Mack Trucks, Inc.
Greensboro, NC USA

Field Service Bulletin Trucks

Battery Starter Lug Failure
CXU, GU

FSB 371-045, Battery Cable Lug, Failure

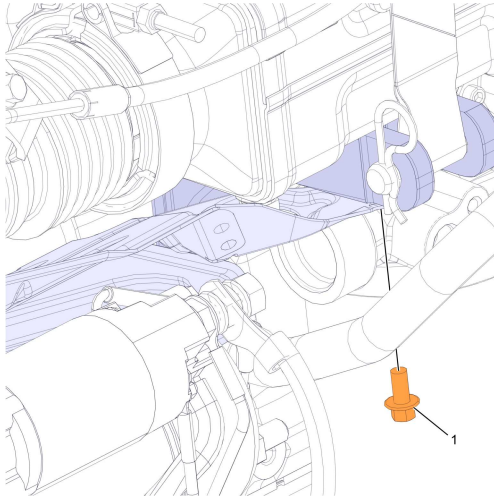
Certain vehicles built from January 1, 2010 to June 14, 2013 with a MP7 engine may experience cracking or breaking of the 90 degree positive battery cable lug at the starter solenoid stud. In some cases, the lug is bent during assembly, and along with engine vibration may cause the terminal to weaken and fail over time.

To support the cable and eliminate this failure, follow the procedure below:

W2080360

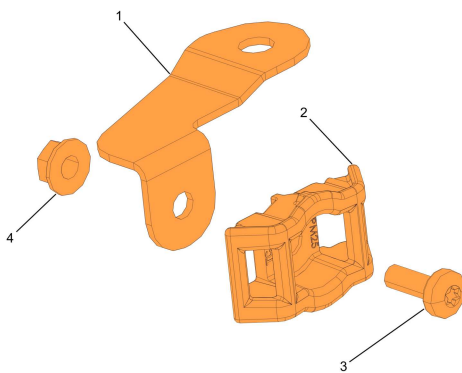
- 1 Secure the vehicle for service by parking it on a flat level surface, applying the parking brake, chocking the rear wheel, and placing the transmission in neutral.
- 2 Disconnect all cables from the negative (ground) battery terminals to prevent personal injury from electrical shock and prevent damage to electrical components.
- 3 Remove the fastener from the heat shield bracket.

W2080361

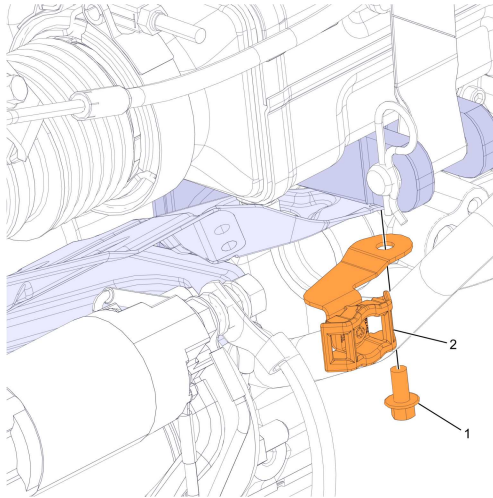
- 4 Preassemble the bracket and the saddle.

W2080362

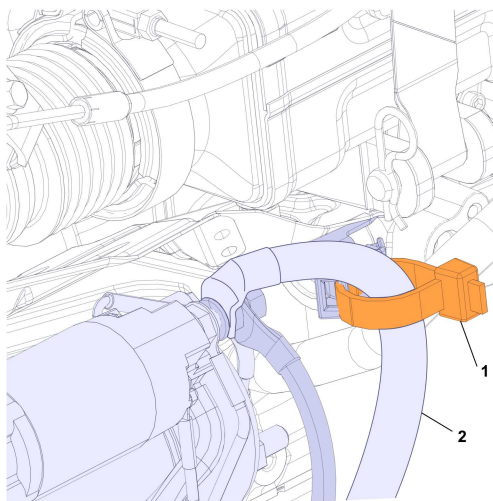
- 5 Install the bracket onto the vehicle and secure.
